RE: Review of the Sonoita Creek Mitigation Project Proposal for the Proposed Rosemont Copper Mine

Review of the Sonoita Creek Mitigation Project Proposal for the Proposed Rosemont Copper Mine

G. Mathias Kondolf, PhD 2241 Ward Street, Berkeley CA mattkondolf@gmail.com

29 December 2017

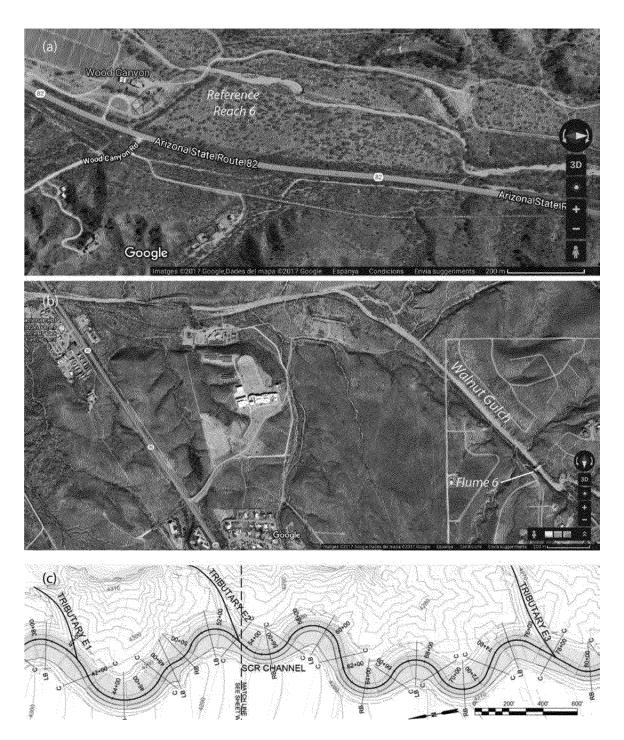
WET (2017:25) states that the reconstructed channel sinuosity "mimics the measured sinuosity of natural, least-altered reaches of Sonoita Creek...Typical values of sinuosity observed in the least altered reaches of Sonoita Creek ranged from 1.1 to 1.4." This statement is not true. The asserted values do not agree with my independent measurements of sinuosity for the existing reaches of Sonoita Creek. For Sonoita Creek in Rail X Ranch, I measured a sinuosity of 1.07; from 'Reference Reach 6' downstream to the point where Sonoita Creek becomes adjacent to Hwy 82, a sinuosity of 1.07 (Figure 1a); and from the end of the Hwy 82 adjacent section to the road crossing downstream of Reference Reach 8, a sinuosity of 1.29. The latter value is exceptional, occurring only in this more sinuous and dynamic reach. The "typical" values are certainly lower, and well represented by the measured 1.07. Sinuosity does not reach 1.4 on these reaches of Sonoita Creek. At the Reference site 6, which was used by WET (2017) as a basis for design of the proposed channel reconstruction, the channel is nearly straight, as reflected in the measured sinuosity of 1.07.

Similarly, WET (2017) also uses Walnut Gulch near Flume 6, in the Walnut Gulch Experimental Watershed near Tombstone, Arizona, as a reference reach (Figure 1b). This reach is almost perfectly straight before going through an approximately 30-degree bend to the left, and thus depending on the length of reach selected, its sinuosity could be as low as 1.0 (taking only the straightaway before the bend), or about 1.07 (including the bend and continuing downstream to the highway bridge). Thus, this reference reach does not provide support for a highly sinuous channel design on Sonoita Creek.

WET (2017:25) states "The restored channels have a sinuosity that ranges from 1.1 to 1.2." This is false. The proposed channel design is much more sinuous than asserted in this statement, much more sinuous than the existing channels in Sonoita Creek, and more sinuous than the reference reaches in Sonoita Creek and Walnut Gulch (Figure 1).

The proposed meandering channel has a sinuosity of about 1.39, as measured from Tributary E1 confluence to the Tributary E3 confluence (Figure 1c). This would be a very large increase in sinuosity over the typical sinuosity of 1.07 prevailing today. This has significant implications for the proposed mitigation project. As discussed below, to build a channel with such an artificially high sinuosity imposed is likely unsustainable, and after a few moderate storms, the result would probably be that the meander bends wash out, leaving a shorter, straighter channel.
